J. H. FLETCHER & CO. Box 2187 - Huntington, WV 25722-2187 - 304/525-7811 - FAX 304/525-4025

INFORMATION BULLETIN NO. 94

SUBJECT: FLETCHER OPERATOR CANOPIES

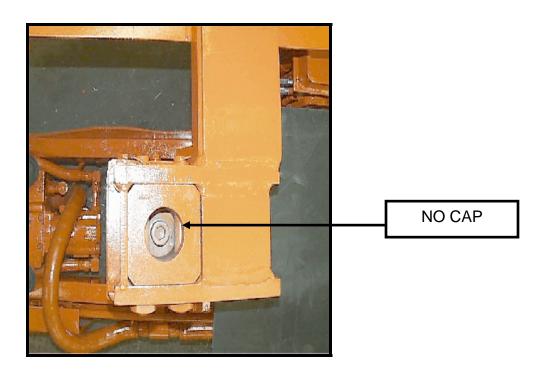
This bolt must be checked weekly - making sure it is in place and properly tightened.

Whenever re-assembling the driller canopy support post assembly, always use a genuine Fletcher OEM replacement bolt and tighten to 150 ft-lbs.

ARROWS INDICATE LOCATION OF CANOPY ATTACHMENT BOLT

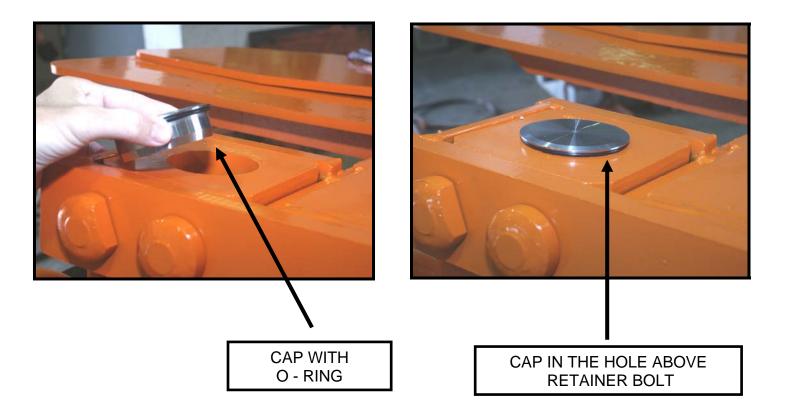
Failure in the connection between the cylinder and tubing can result in an unexpected drop in the driller canopy at some point after the CANOPY control lever is operated in the "canopy lower" direction.

In response to this near miss J.H. Fletcher & Co. recommends that all operators be made aware of this potential problem and emphasizes that the service manual requirement of weekly torque checks be performed to ensure that the bolt is tightened to 150ft-lbs (see Attachment 1). Fletcher requires the inspection of this connection bolt as part of the weekly torque check. In addition, always check for correct control functions before operating this machine
